**Addendum No. 2**  
**July 29, 2024**

Project: Brandon Valley Elementary School  
Brandon, South Dakota  
Project #3023

Architect: Architecture Incorporated

1 FRAMING DETAIL  
3.54 NTS

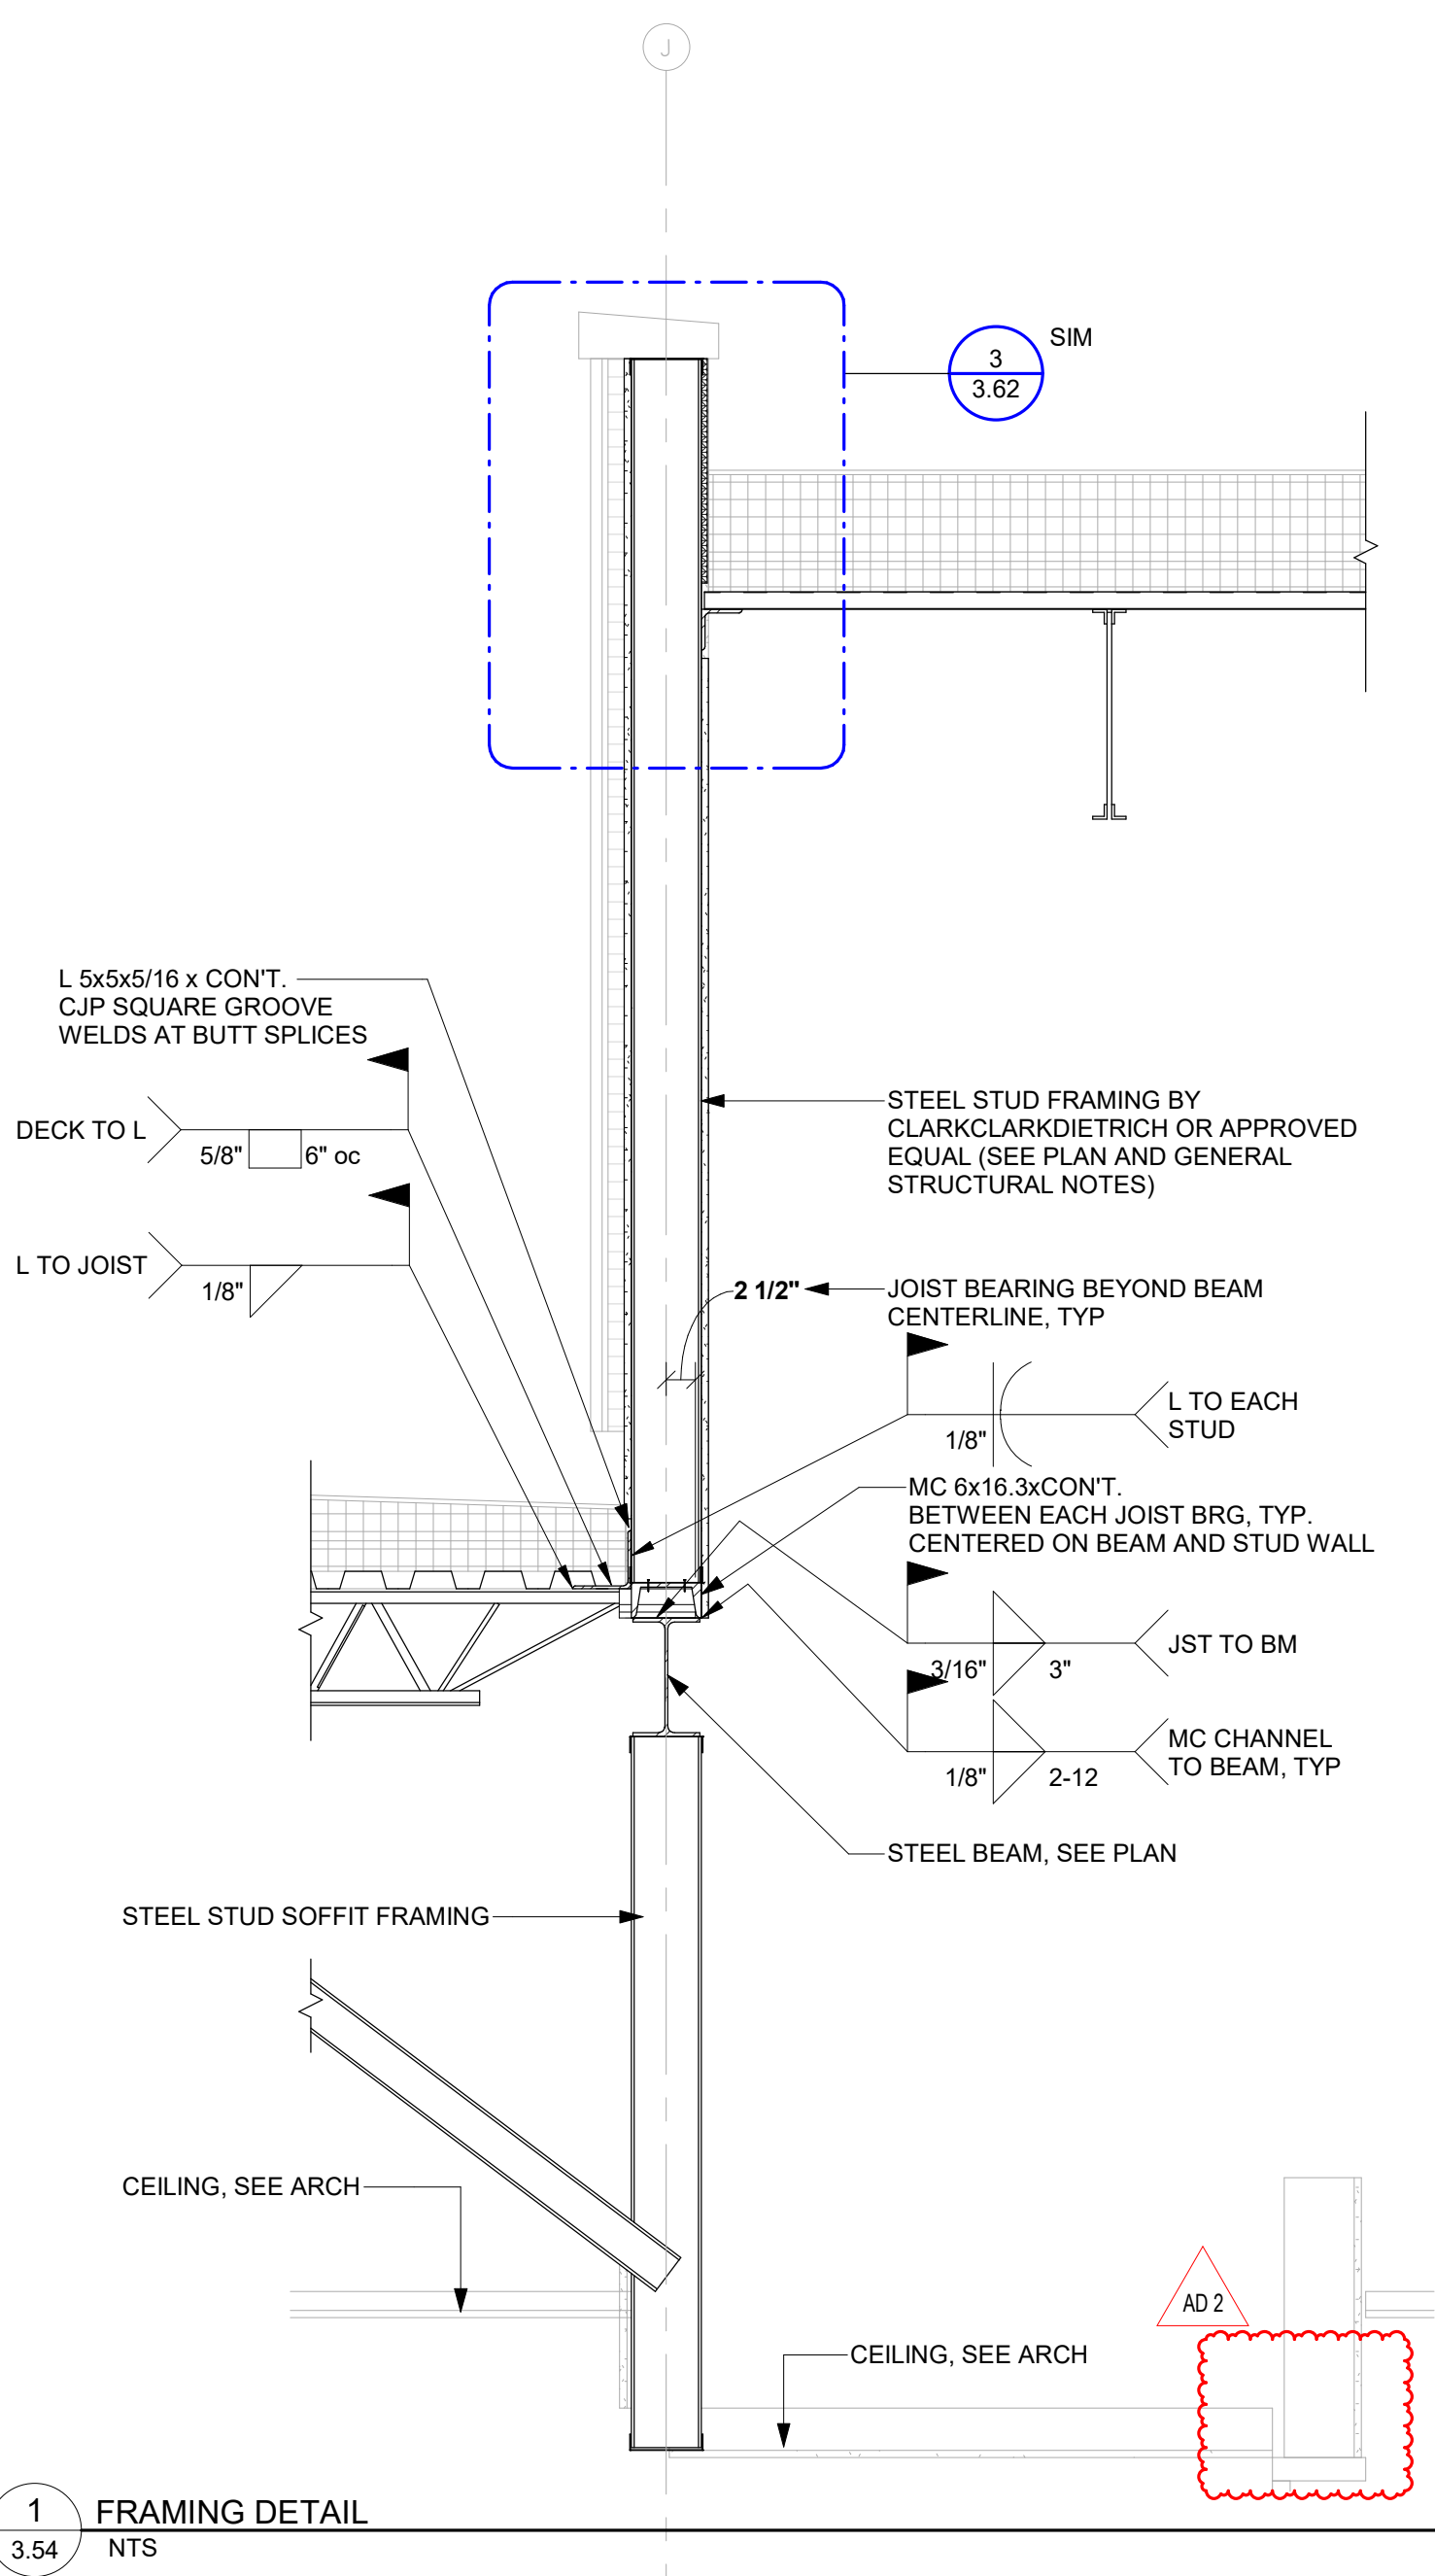
- a) Omit the Lintel L4 originally shown over door C100 as indicated in revised detail 1/3.54; reference *revised* Sheet 3.54, *revision* dated 7-26-2024, attached to the end of Addendum #2.

MEZZANINE PLAN - AREA B

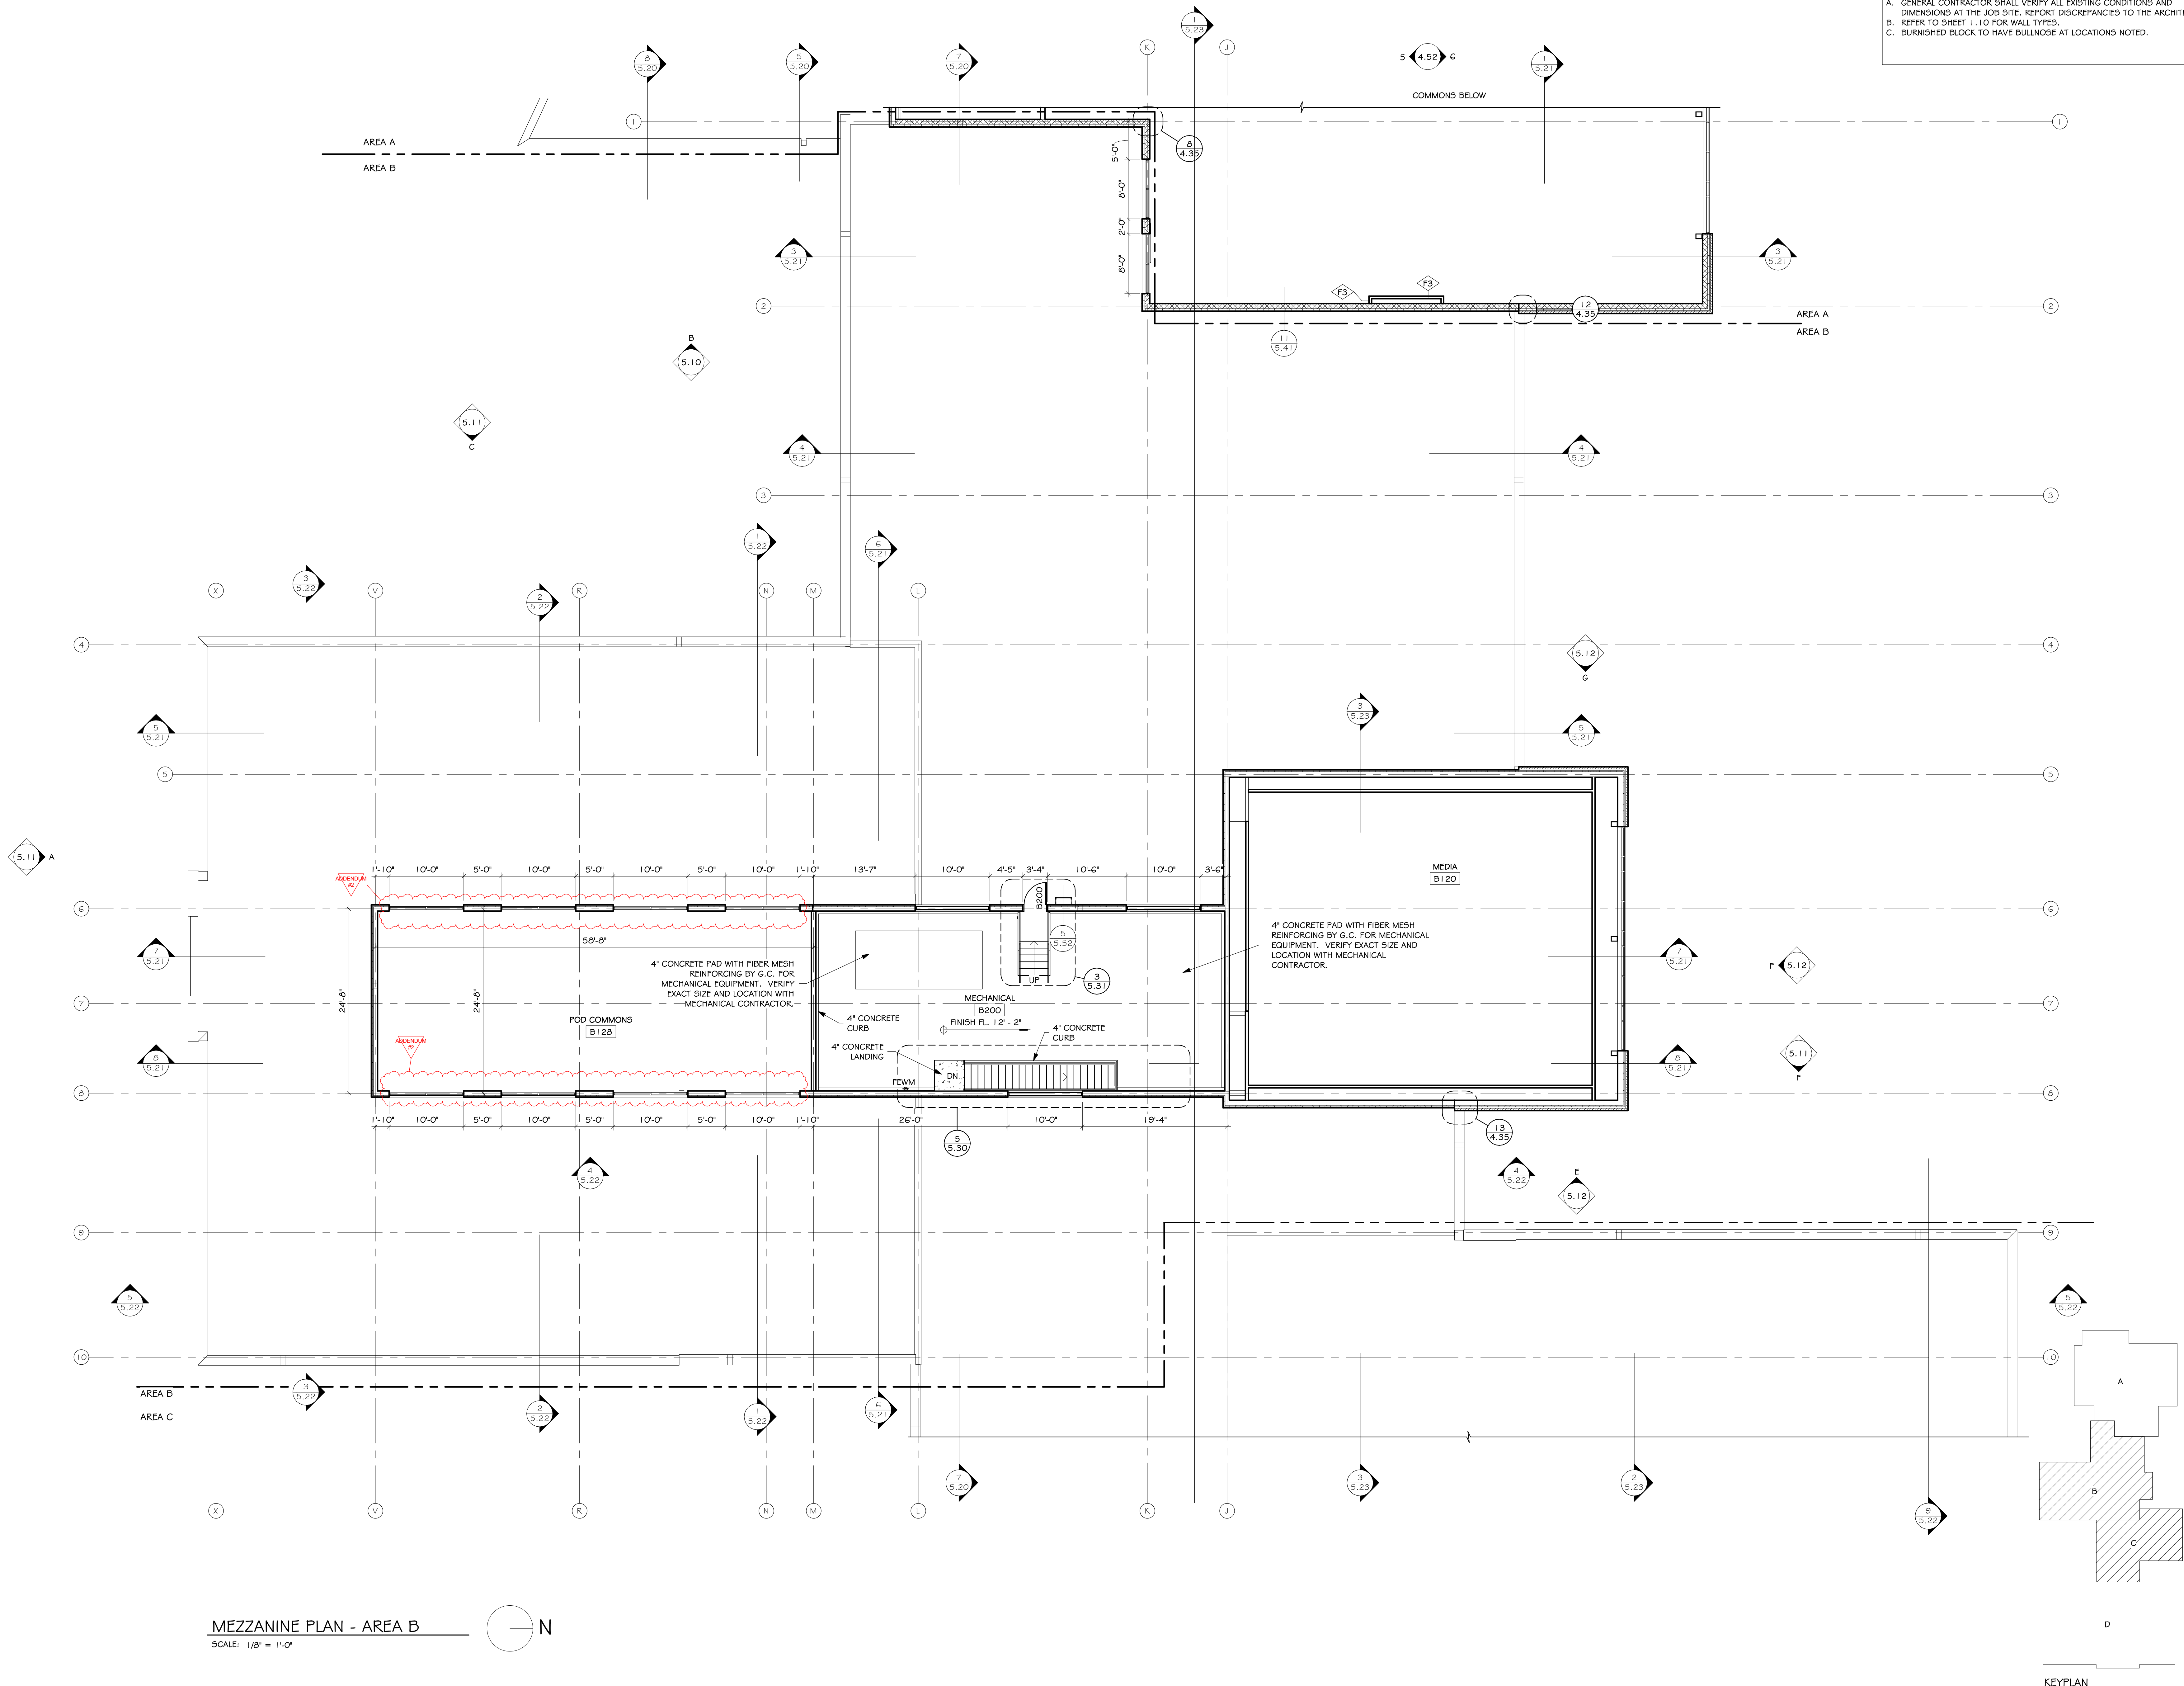
- a) Reference *revised* drawing Sheet 4.11B, *revision* dated 7-26-2024, attached to the end of Addendum #2 for the following modifications:
- i) The floor plan has been adjusted to show clerestory windows originally not visible on the floor plan.

MEZZANINE PLAN - AREA C

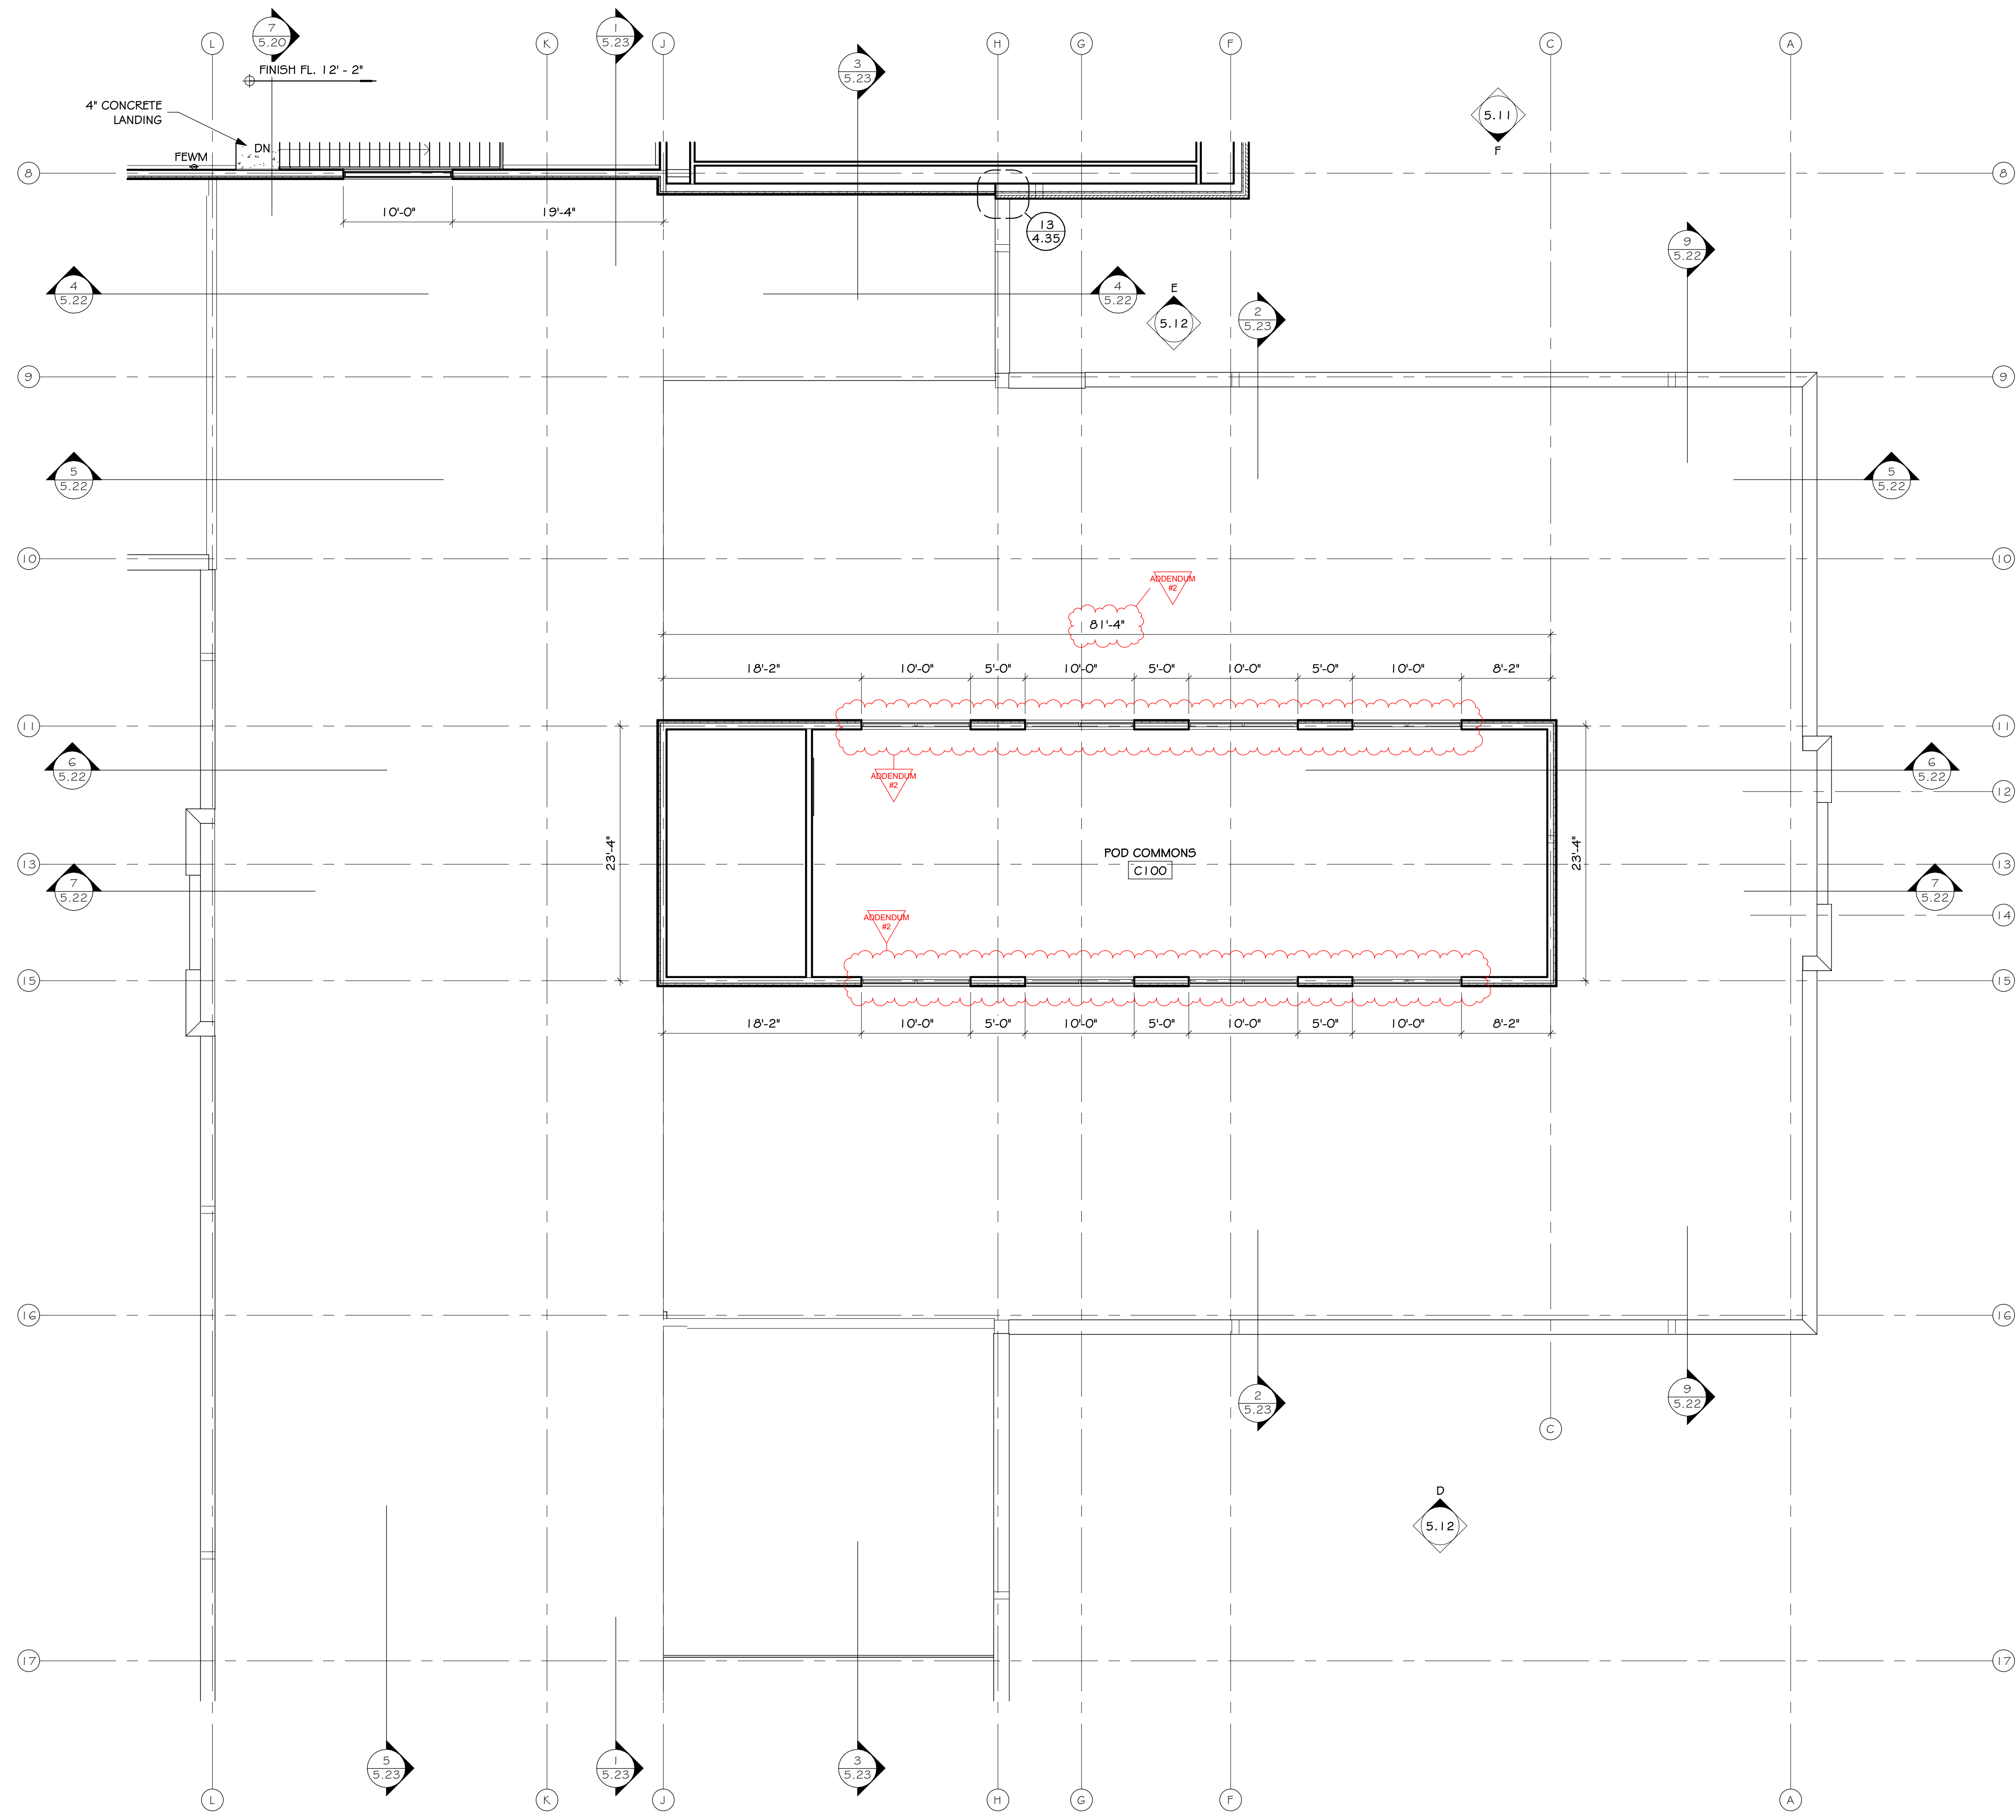
- a) Reference *revised* drawing Sheet 4.11C, *revision* dated 7-26-2024, attached to the end of Addendum #2 for the following modifications:
- i) The floor plan has been adjusted to show clerestory windows originally not visible on the floor plan.
- ii) Overall dimension has been added along the west wall as indicated.
